**State of West Virginia
 Solicitation Response**

Proc Folder: 1593441
Solicitation Description: Ditch, Pipe and Asphalt Repair and Maintenance by the Vendor
Proc Type: Agency Master Agreement

Proc Folder: 1593441			Reason for Modification: Addendum 01 To attach responses to questions from vendors and revised specifications.
Doc Description: Ditch, Pipe and Asphalt Repair and Maintenance by the Vendor			
Proc Type: Agency Master Agreement			
Date Issued	Solicitation Closes	Solicitation No	Version
2025-01-15	2025-01-23 10:30	ARFQ 0803 DOT2500000026	2

REPAVING PIPE TRENCHES IN PAVED SHOULDER

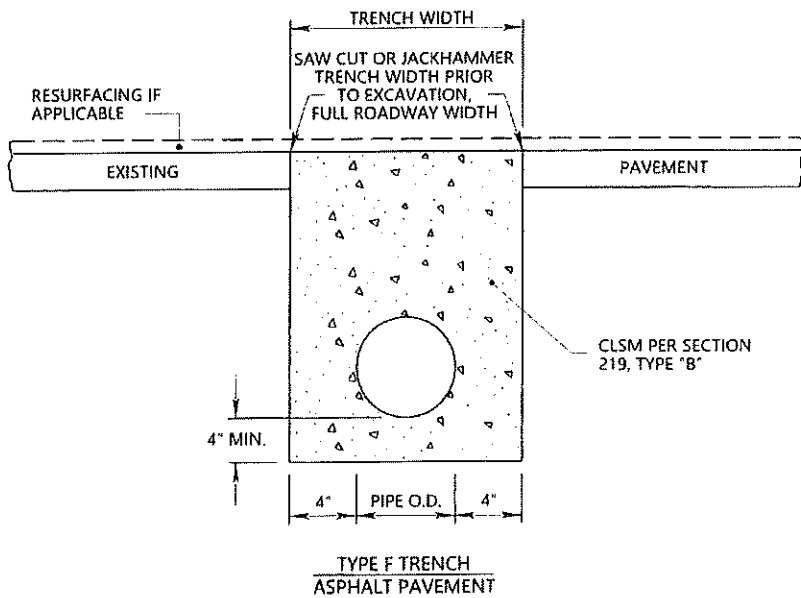
Question 3

While this contract does not dictate the means and methods, work shall be carried out in accordance with Standard Specs 207, and 604. Pipe Repair & Replacement shall meet the requirements of the Standard Detail for Repaving Pipe Trenches F, EXH 1, Page 5, or as identified by the Delivery Order or the WVDOH District Engineer.

THE WEST VIRGINIA DEPARTMENT OF TRANSPORTATION DIVISION OF HIGHWAYS
BASE FAILURE REPAIR DETAIL

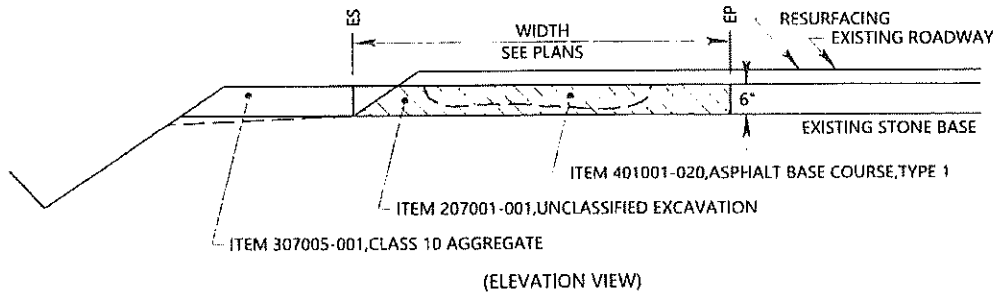
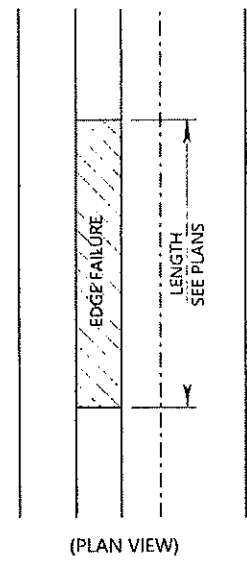
3.2.4.3 has a NOTE that "Varies" shall mean for every 3 inches of asphalt, there shall be 6 inches of stone, unless specified otherwise by the Engineer. The Base Failure Repair Detail states that the aggregate is estimated at 6". What should we use in estimating to establish our pricing?

Vendor should use the following when estimating: "For every 3 inches of asphalt, there shall be 6 inches of stone, unless specified otherwise by the Engineer." Additional language has been added to the NOTE for situations that significantly exceed the asphalt and/or stone requirements of these sections.
